PLANNING TECHNICAL REVIEW COMMITTEE –AGENDA

1. Site Plan for First Rate Real Estate Group, LLC, Assessor's Map 26, Lot 3-1, zoned G and RM-U, located at 75 Oak Street. (Proposal is to renovate and redevelop the existing building into twenty-two (22) residential units with site improvements.) (SITE-2026-0009)
[This item was previously heard by the Planning Technical Review Committee on June 11, 2026.]
2. Site Plan for 12 Lincoln Street Dover, LLC, Assessor's Map 31, Lot 67, zoned CBD-R, located at 12 Lincoln Street. (Proposal is for the addition of a third floor to the existing structure with eight (8) additional units, for a total of nineteen (19) residential units.) (SITE-2025-0018)
[This item was previously heard by the Planning Technical Review Committee on May 21, 2026.]

PLAN SNAPSHOT REPORT SITE-2026-0009 FOR CITY OF DOVER, N.H.

Re: SITE-2026-0009: 75 Oak Street, Tax Assessor's Map 26, Lot 3-1
Response to Technical Review Committee Comments, dated June 11, 2026

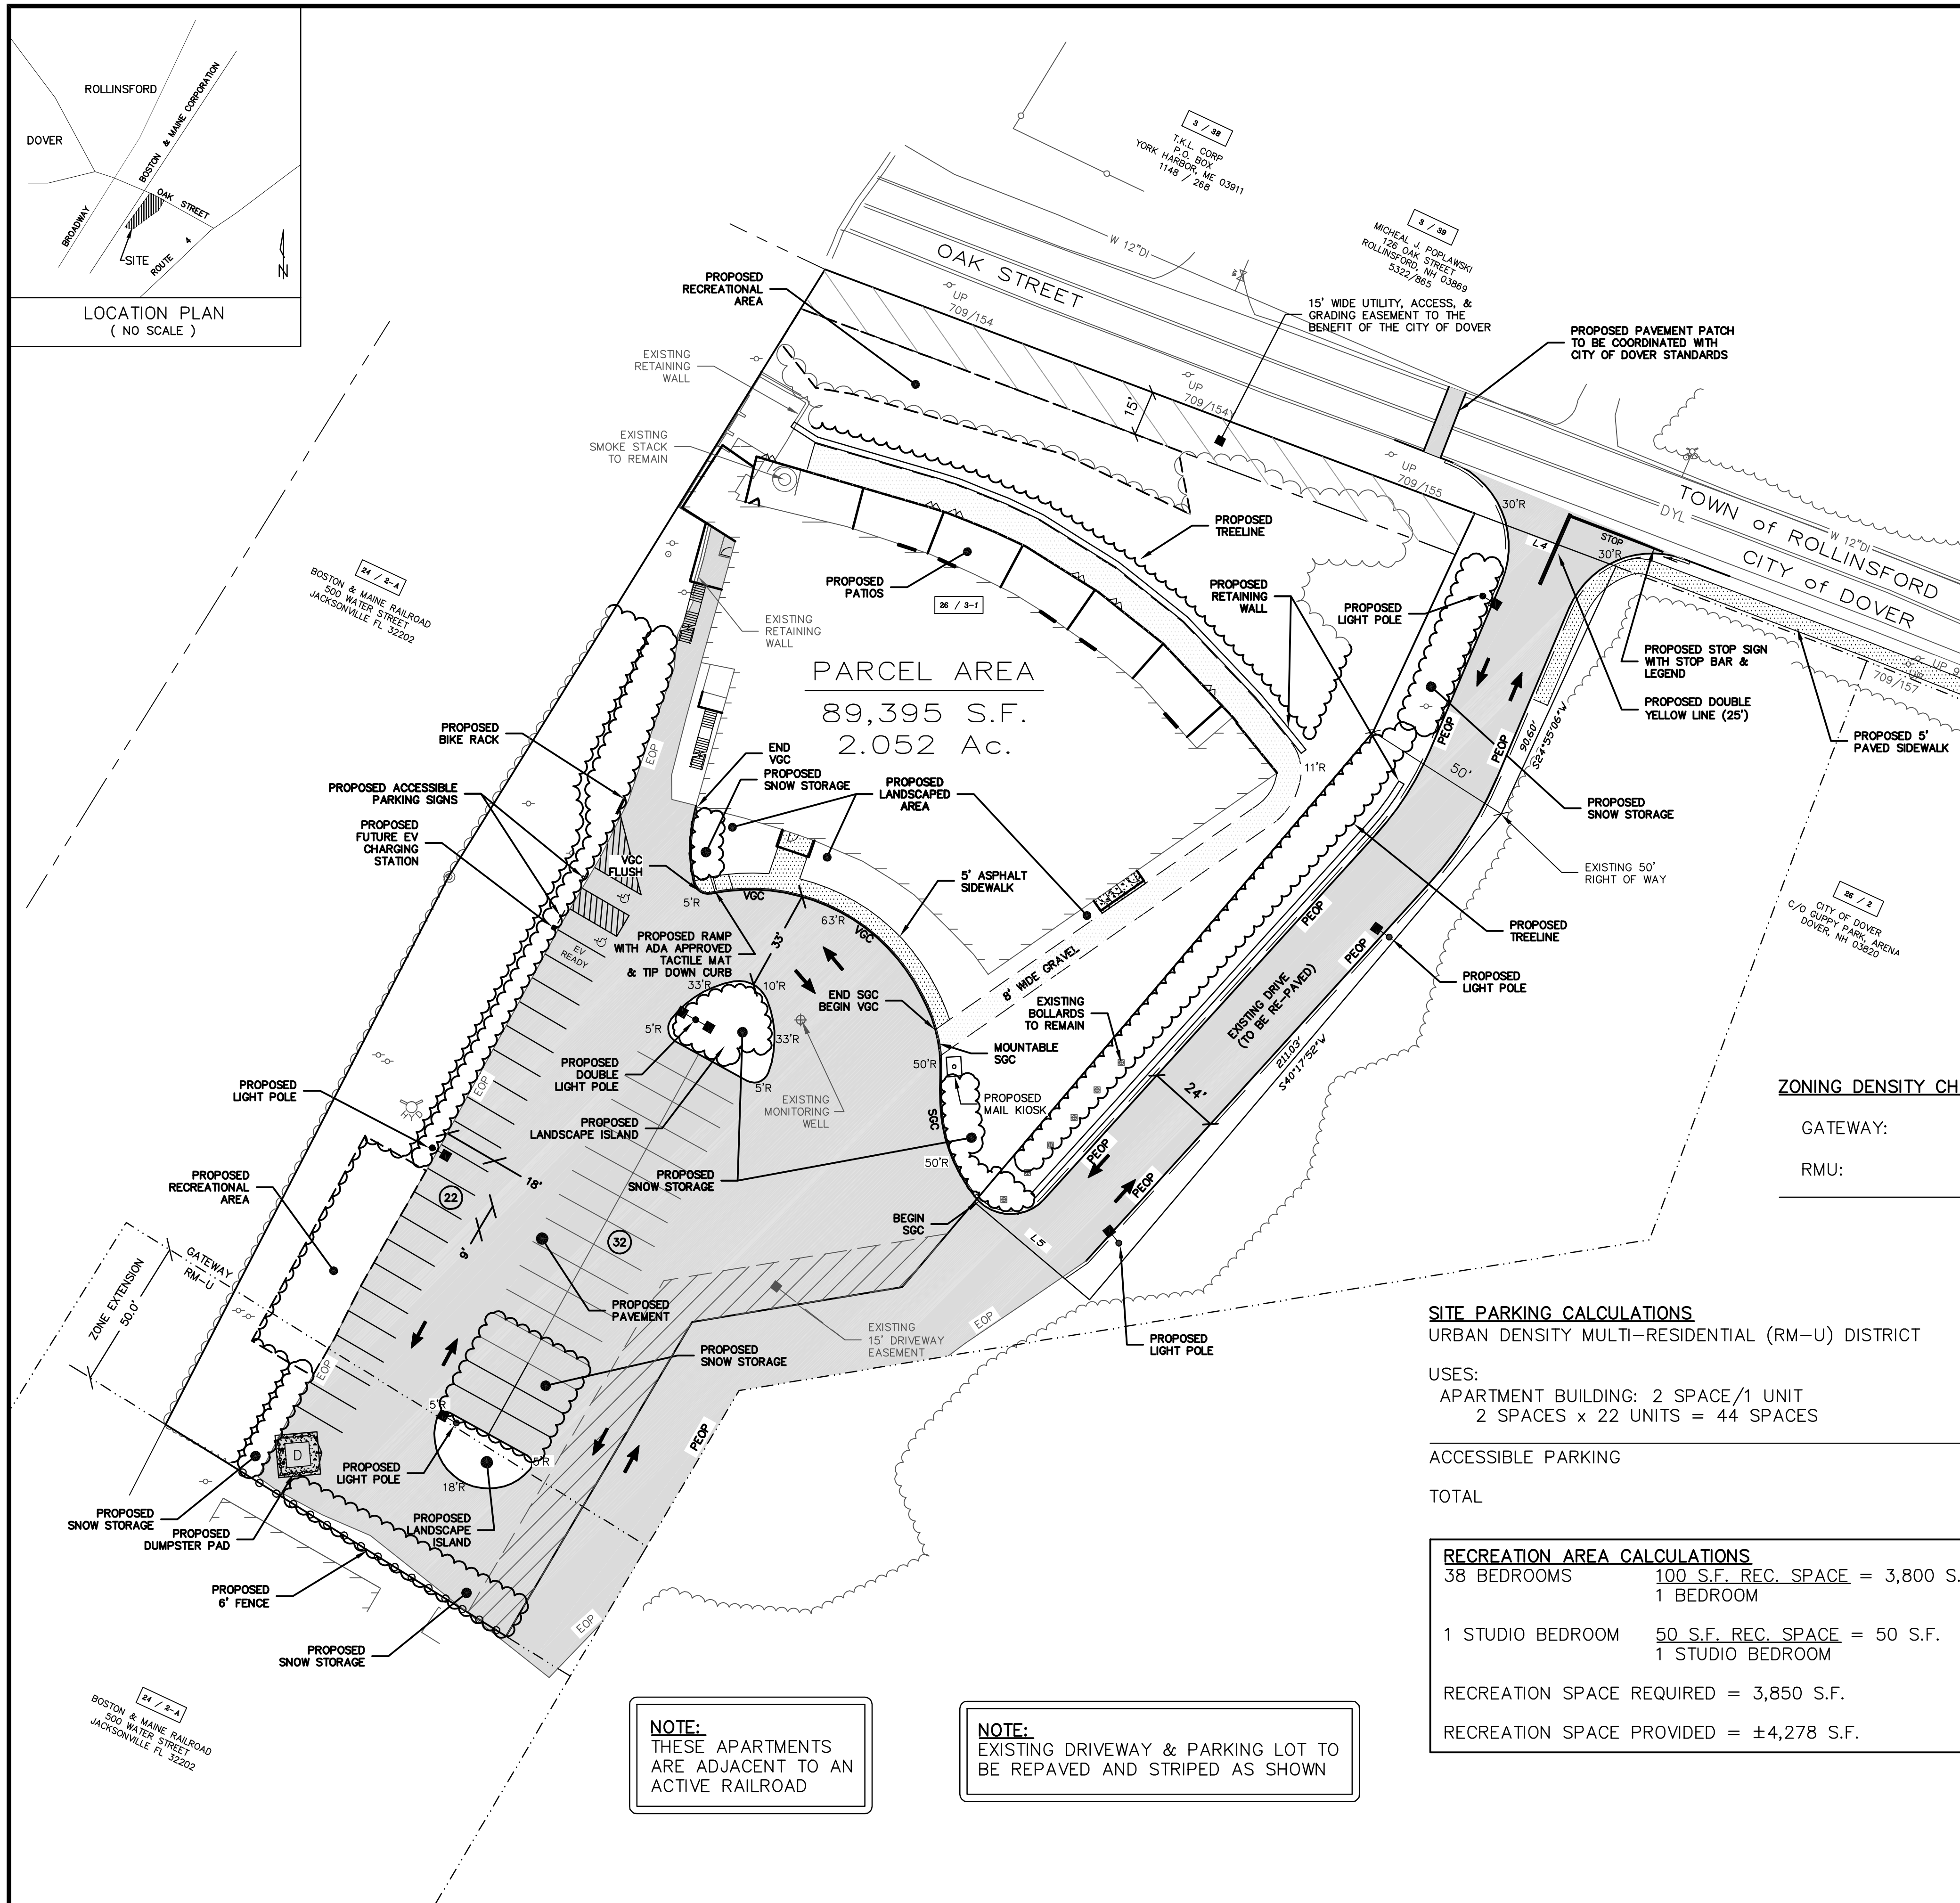
- 3) *Confirm discharge location for DMH 1 Inv. 4*
Acknowledged. Discharge location has been confirmed.
- 4) *Recommend removal of existing landscape island with sign and driveway entrance*
Landscaped island to be removed. Work to be completed is shown on the Demolition plan (sheet 5).

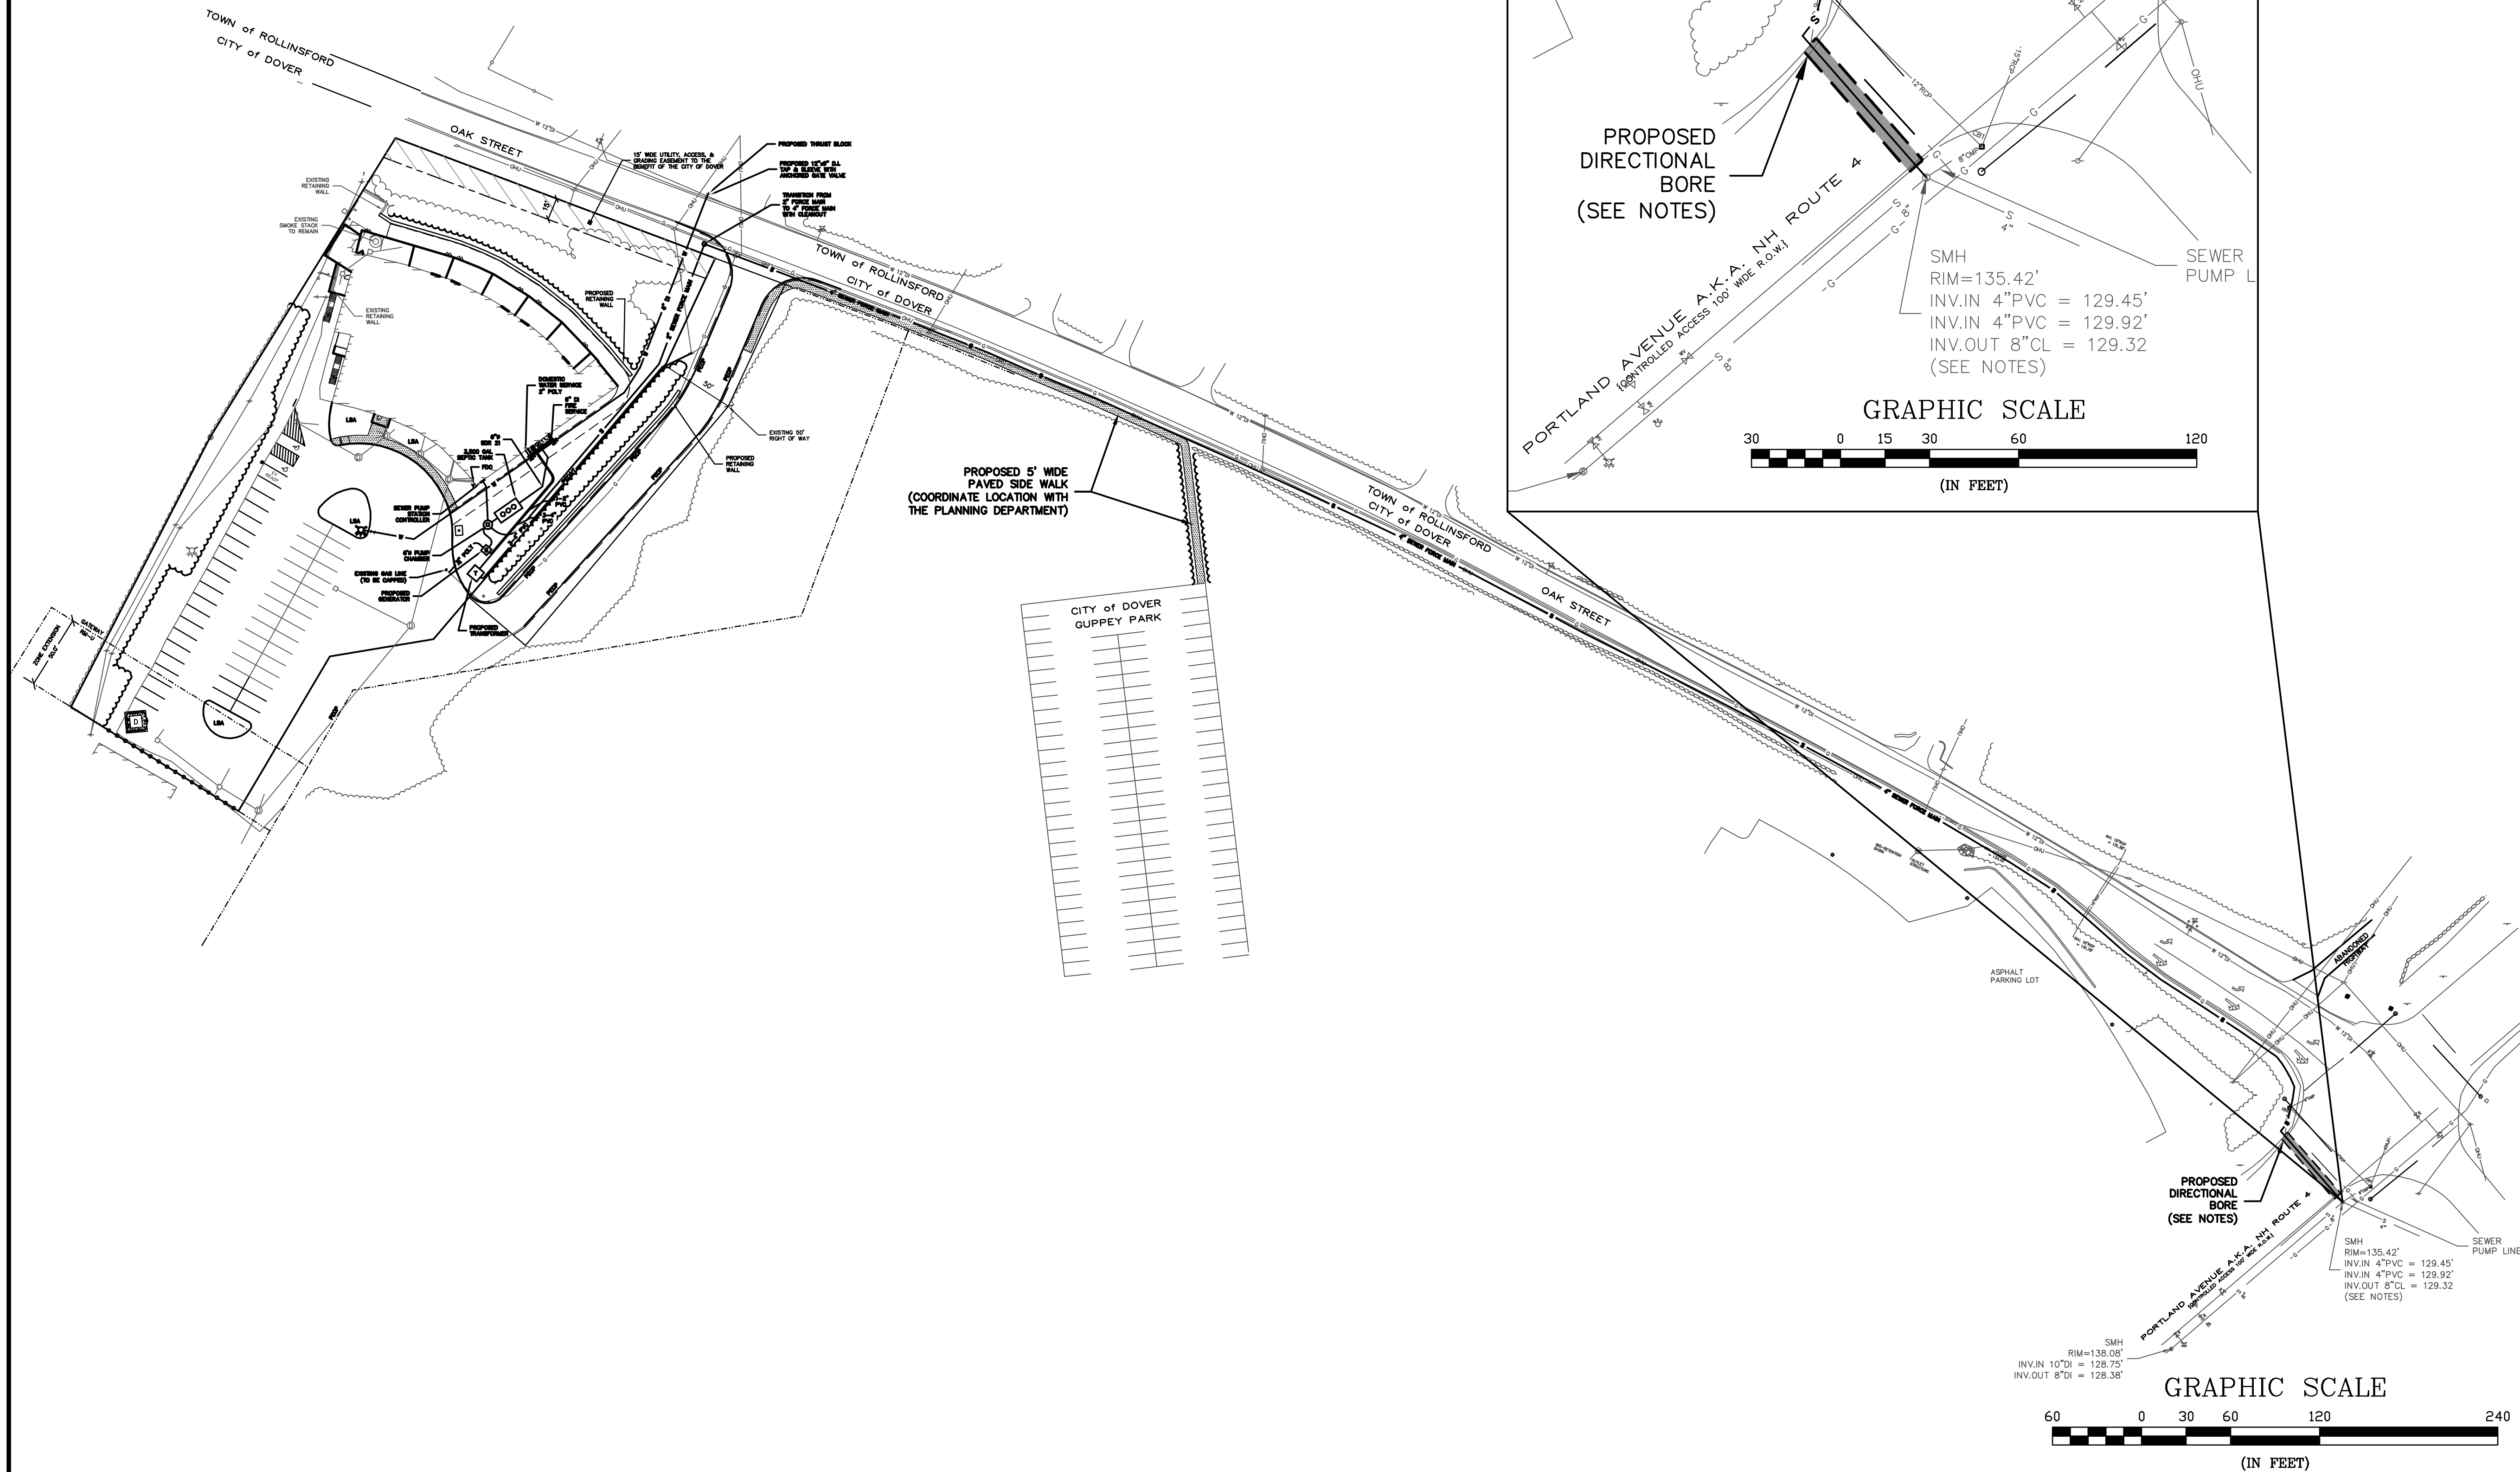
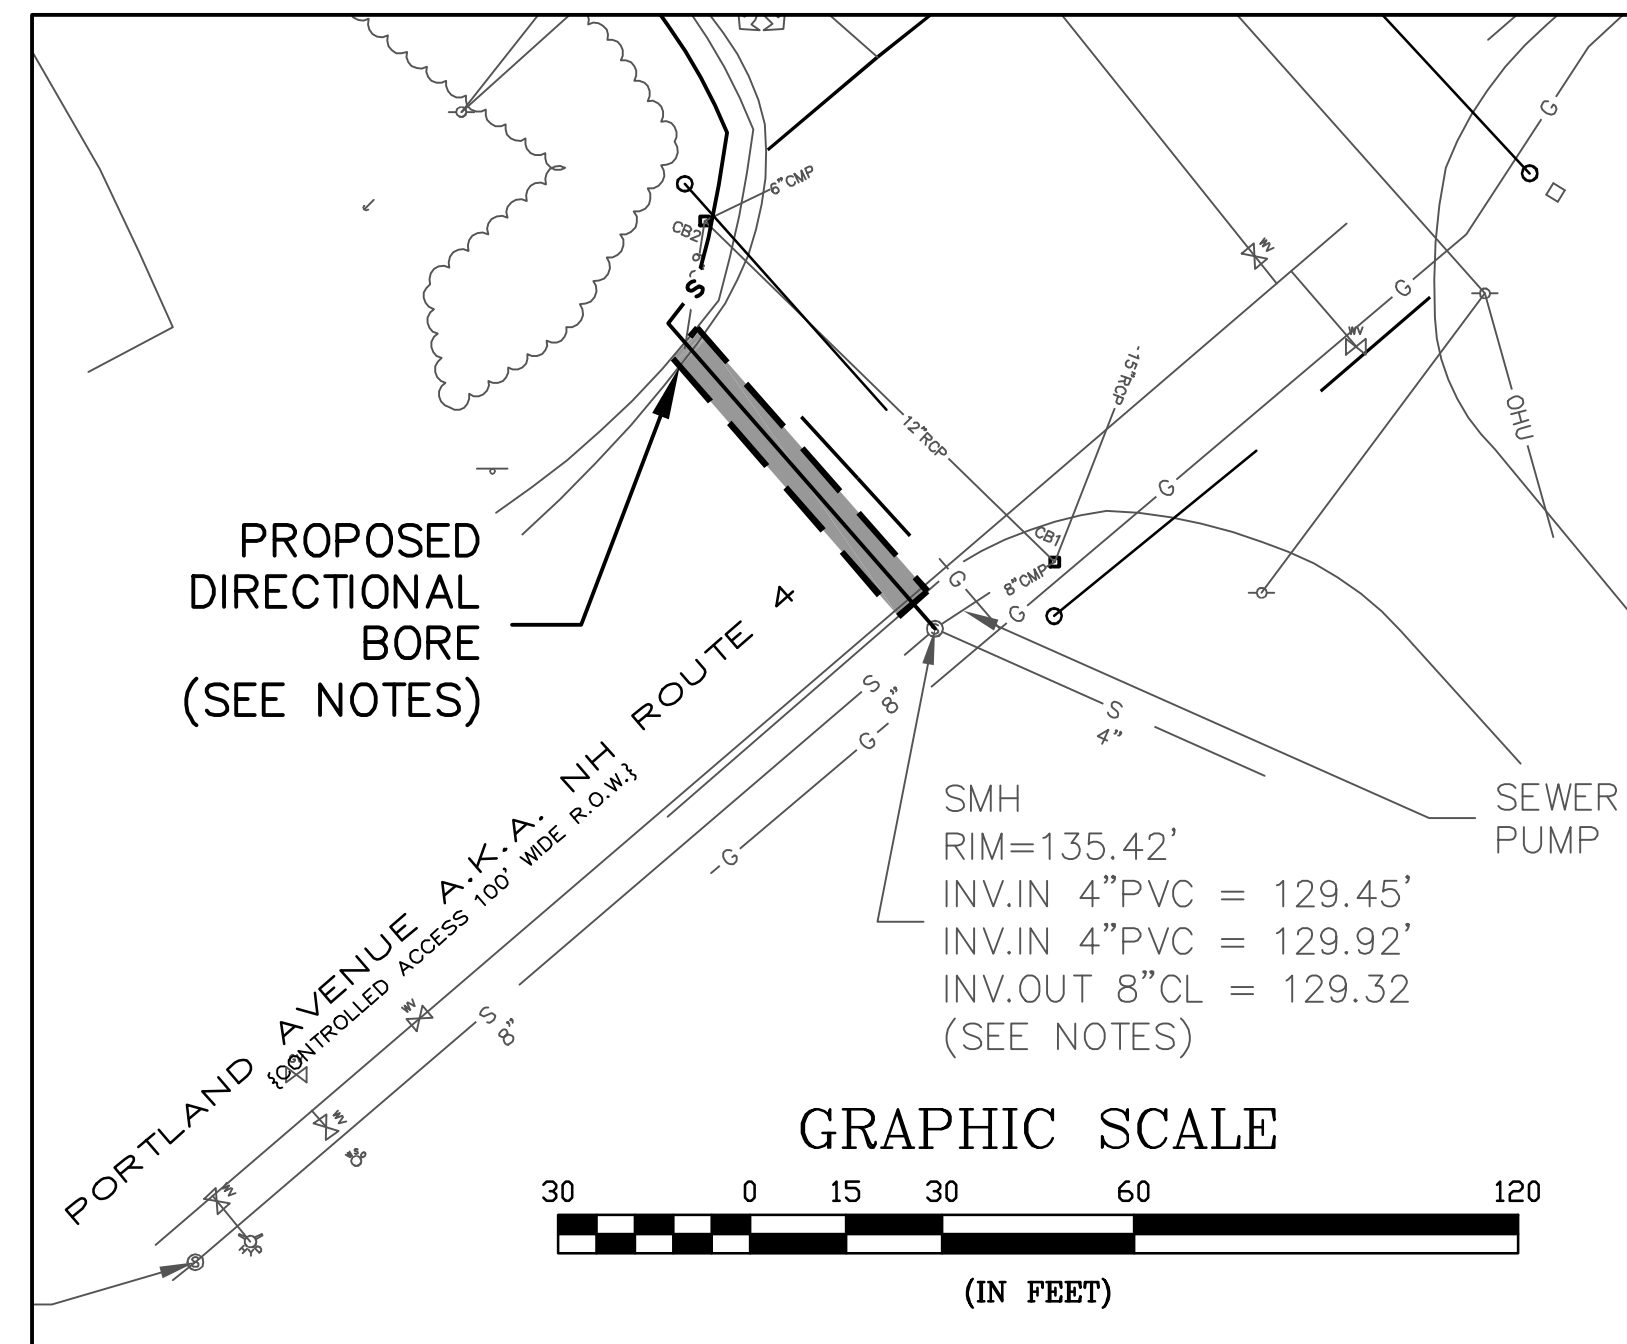
- 10) *Overall Utility Plan doesn't show traffic light cabinet, underground conduit, and traffic loops*
Acknowledged. City engineer to provide data.
- 11) *Structure recommended at force main transition from 2" to 4"; otherwise may be difficult to clean*
The plans have been updated to include a sewer cleanout at the 2" force main to 4" force main transition.

TYPICAL STANDARD PAVEMENT SECTION

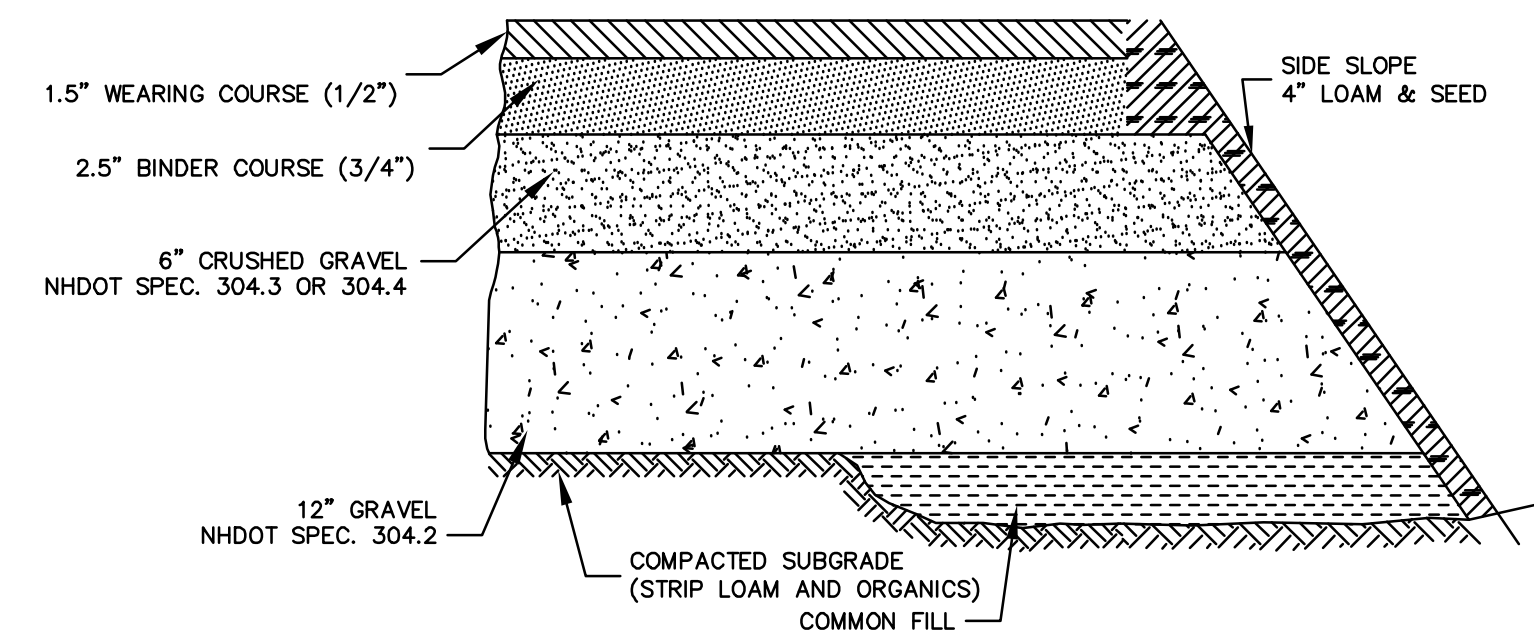
- 6) *Confirm if existing driveway is to be repaved in addition to the parking area*
Existing driveway and parking area are to be repaved.
- 7) *Detail sheet 12 Typical Standard Pavement Section 8" gravel should be minimum 12" per city detail.*
The detail sheet has been updated accordingly.
